**La Rosa Pump Station Rehab**  
**Solicitation Number: CO-00314-SM**  
**Job No.: 18-6001**

**ADDENDUM 2**  
**1/30/2020**

**S-206**

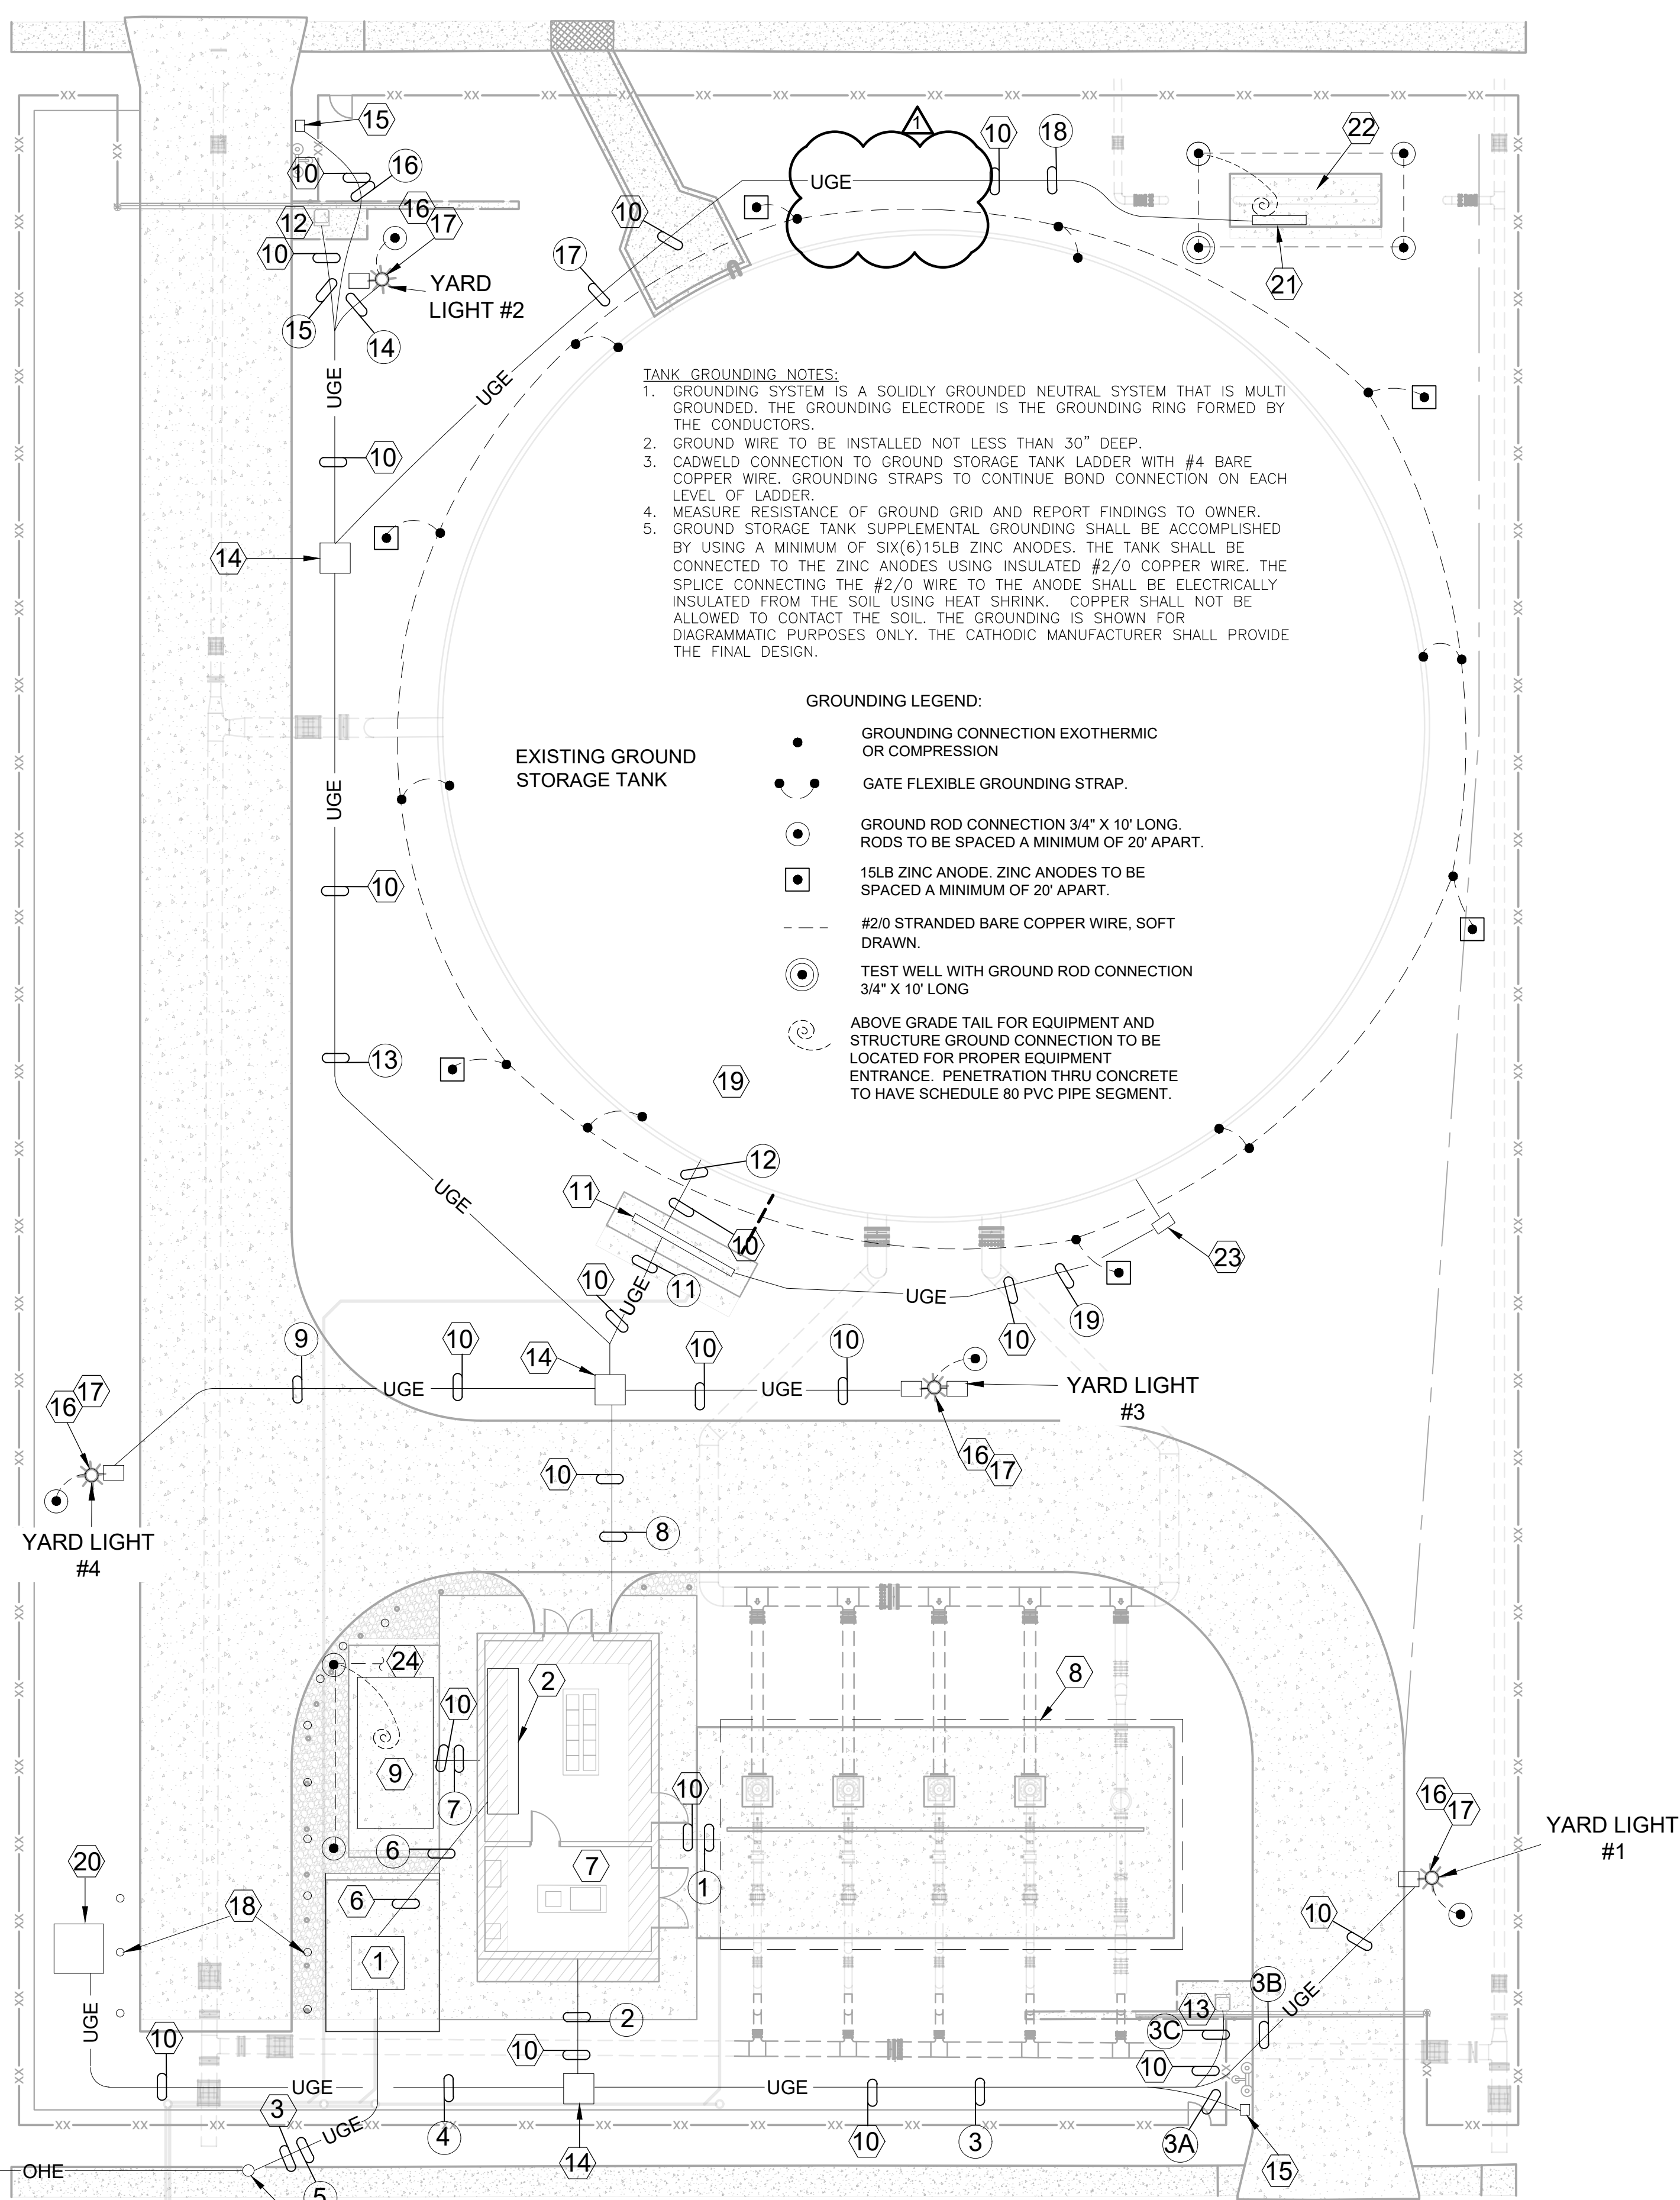
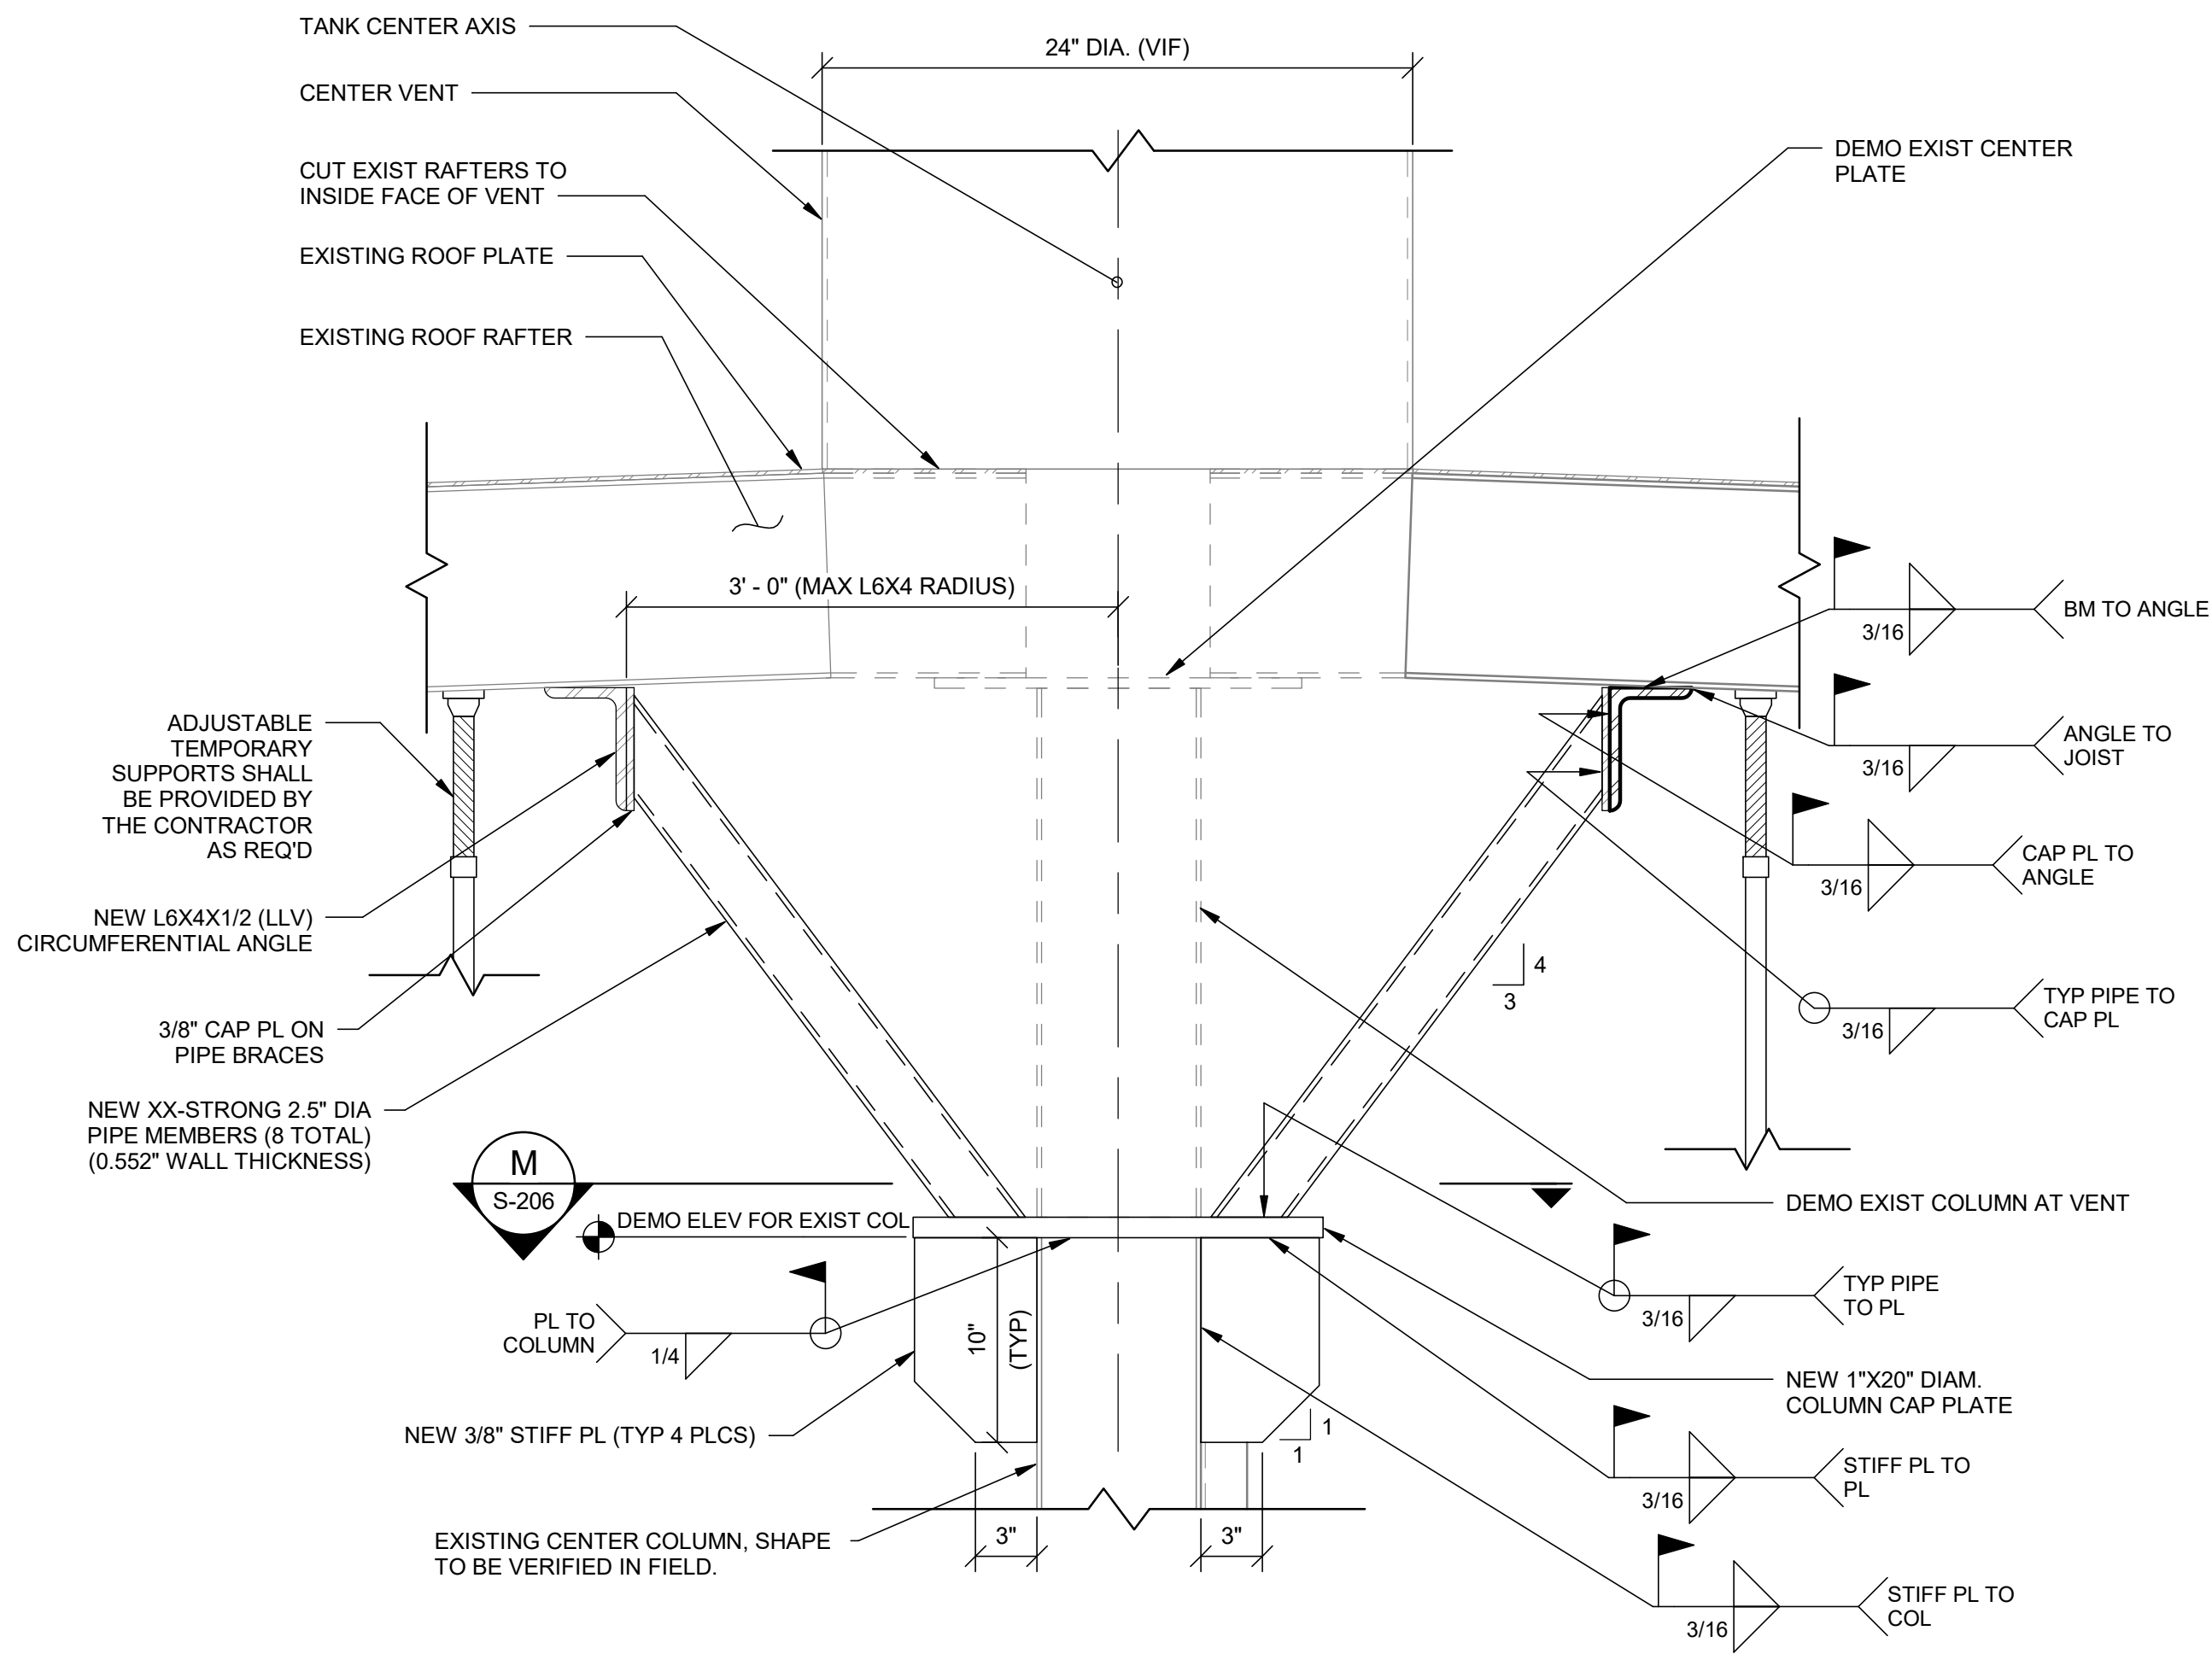
18. Bid Item 3B shows a quantity of 20 EA. for the interior perimeter angle brace replacement, but Detail L on S-206 has a note that says to base bid on 64 EA. Please confirm the actual quantity to be included in the bid.

Response: Detail L on S-206 has been updated, refer to drawing S-206 – STRUCTURAL CROWS NEST DETAILS in the CHANGES TO THE PLANS of this Addendum.
